Technical Service Bulletin: tsb080038	Released Date: 06-May-2008
Cylinder Block and Centinel™ Valve Bracket

Cylinder Block and Centinel™ Valve Bracket

01d00418

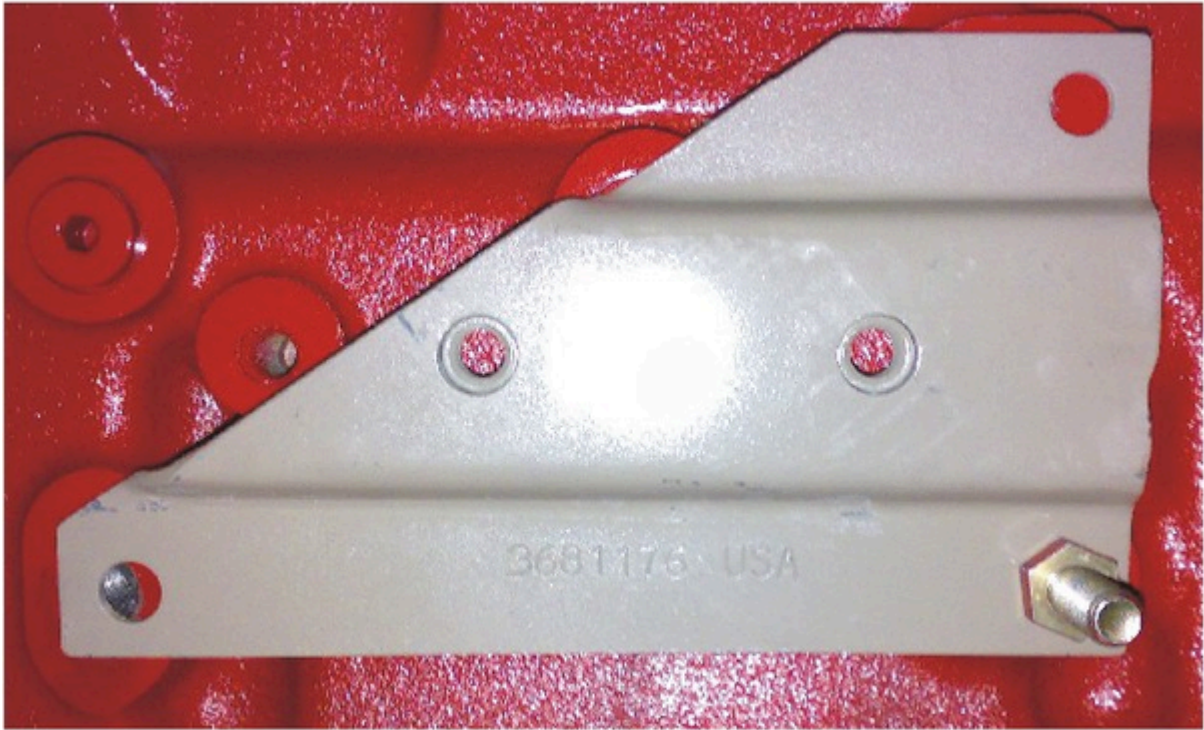
This Early Field Notification addresses an incompatibility issue between the present production cylinder block, Part Number 4965679 and Centinel™ valve bracket, Part Number 3681176. The Centinel™ valve bracket does **not** mount to the present cylinder block.

The Centinel™ valve bracket will **not** mount to the cylinder block.

The Centinel™ valve bracket mounting hole, located on the bottom right, as viewed in the photo, will need to be slotted approximately 7.5 mm [0.295 in].
